UNITED STATES PATENT AND TRADEMARK OFFICE

APPLICATION NO.	FILING DATE	FIRST NAMED INVENTOR	ATTORNEY DOCKET NO.	CONFIRMATION NO.
09/729,743	12/06/2000	Steven B. Bridgers	P-5200-01-00	7935

Office Action Summary

DETAILED ACTION

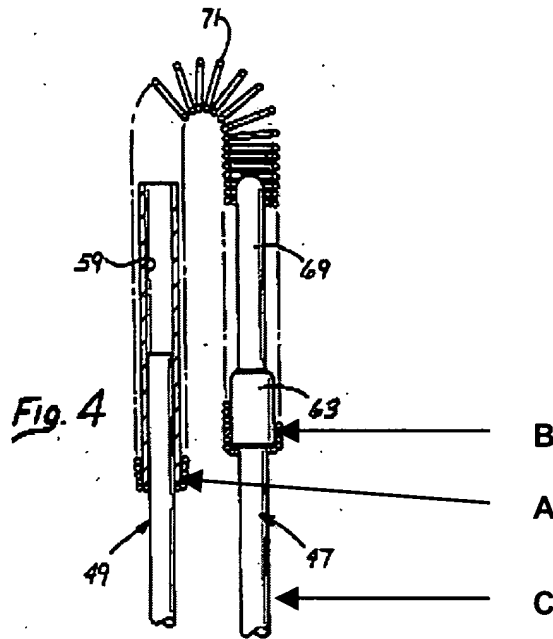
Eppenbach (USPN 5,590,674).

As to claim 19, Eppenbach discloses a connector module having:

a body **57**;

a resilient member **71** accommodating translational (compression of spring **71**) and rotational motion (bending of spring **71**) in more than one plane, the resilient member having a first end **A** connected to the body and a second end **B**;

a strut **47,63,69**, the strut having a first end **63,69** connected to the second end of the resilient member and a second end **C** for connection to another structural element (an identical connector module having a body **57**; Figures 2-5).

As to claim 25, Eppenbach discloses a connector module having a strut **47,63,69** having a telescoping member **69** (telescoping member **69** is telescopically received within cavity **59** of body **57**; Figures 3 and 4).
